E3646A-04C

S E R V I C E N O T E

E3646A DC Power Supply

Metal Strap Kit for tightening loose bumper and for fitting rear lock link in side-by-side rack mounting

Figure 1: Top view 3mm gap observed between two different chassis designs

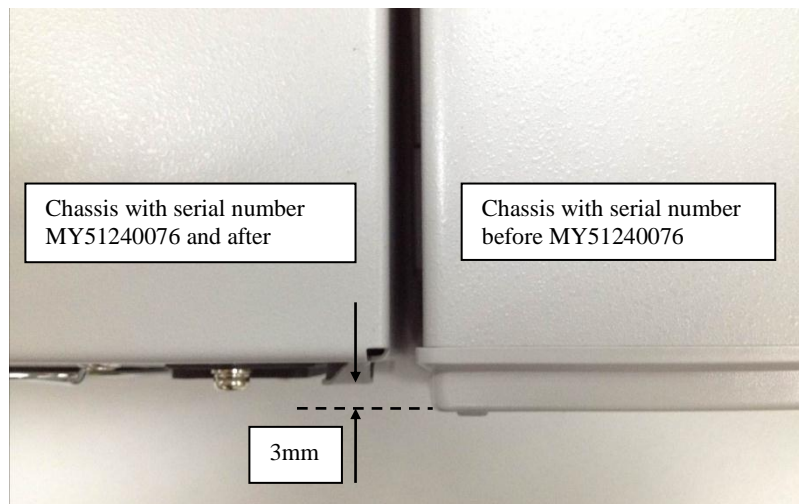
The chassis depth difference between the two designs is 3mm as shown in Table 1 and Figure 1 below.

Serial number range	Chassis depth
MY51240076 and after	345.2 mm
Before MY51240076	348.2 mm

Figure 2: Top view 3mm gap observed on rear lock link for side-by-side rack mounting

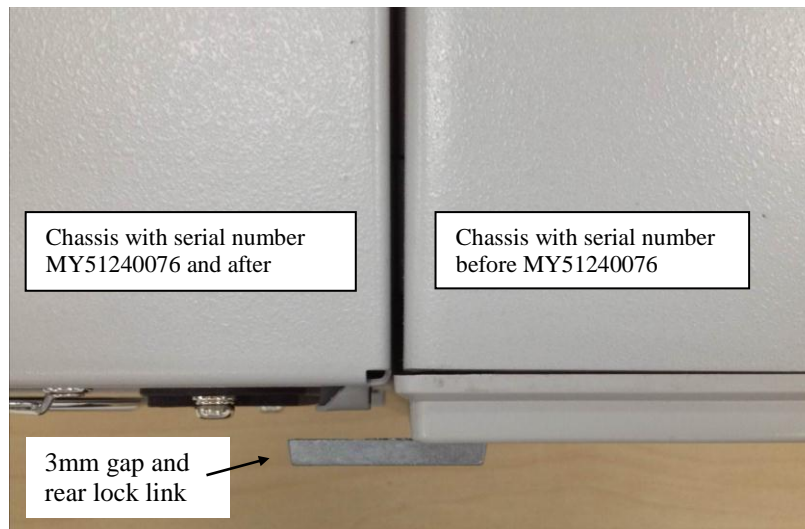
The 3 mm gap between the two different chassis may cause difficulties in securing them together using a rear lock link kit (part number 0050-2167) for side-by-side rack mounting as shown in Figure 2 below.

Use metal strap (part number E3631-07901), and stack the provided two metal straps together to form 3mm thickness and secure it with the provided screws on the rear lock link as shown in Figure 4 below.
